1858 Vaughn - Stacy Hsu
Pulaski, Tr.

March 13, 1984

1858 VAUGHN-STACY HOUSE, PULASKI, TENNESSEE

1858
VAUGHN-STACY
HOUSE - PULASKI, TN.
SKETCH PLAN - JULY 3 '83
HARVIE P. JONES, F.A.I.A.

West Portico

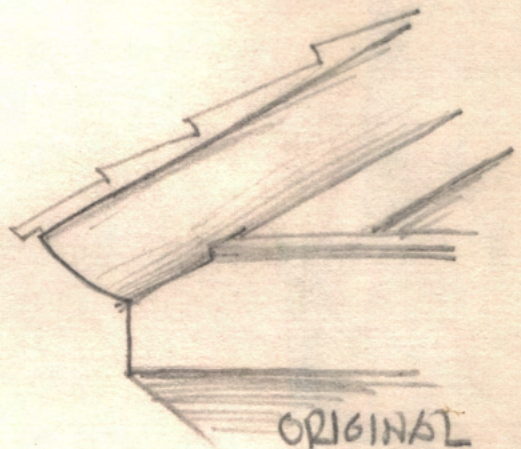
Bohemian
Cranberry
Gl.

Clear
Gl.
probably
was
Bohemian
glass
(broken
pieces found
in basement)

North Portico - added

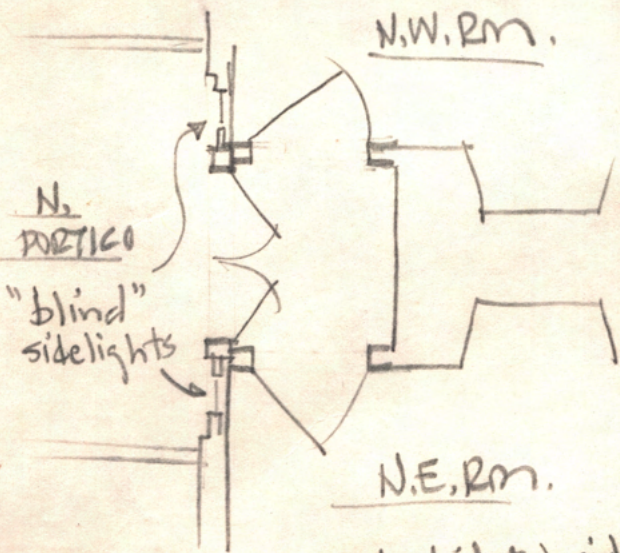
ORIGINAL
CORNICE
(now removed
for gutters)

triangular vent w/
"hardware cloth" is
probably 20th. cent.

toplight & sidelights
= Bohemian
Cranberry Glass
